SUNDRY NOTICES AND REPORTS ON WELLS

Apache # 134

Apache Corporation

Apache Corporation proposes to P&A this well in this manner: All cement - Class B 15.6#/gal. Spacer fluid - fresh water.

WELL NAME APACHE 134
FORMATION DAKOTA
API: 30 03922658
NE/SW SEC 10 T24N R4W
RIO ARRIBA, NM

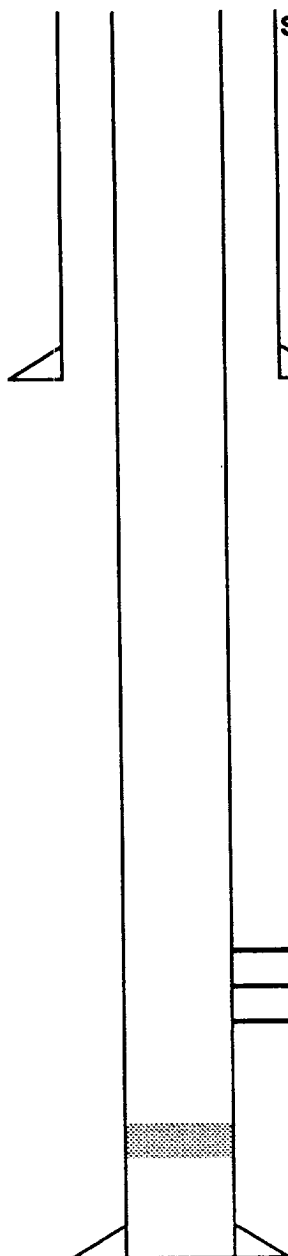
attached IF #6 holds, surface plug @ minimum of 100'

1400'
10/17/00
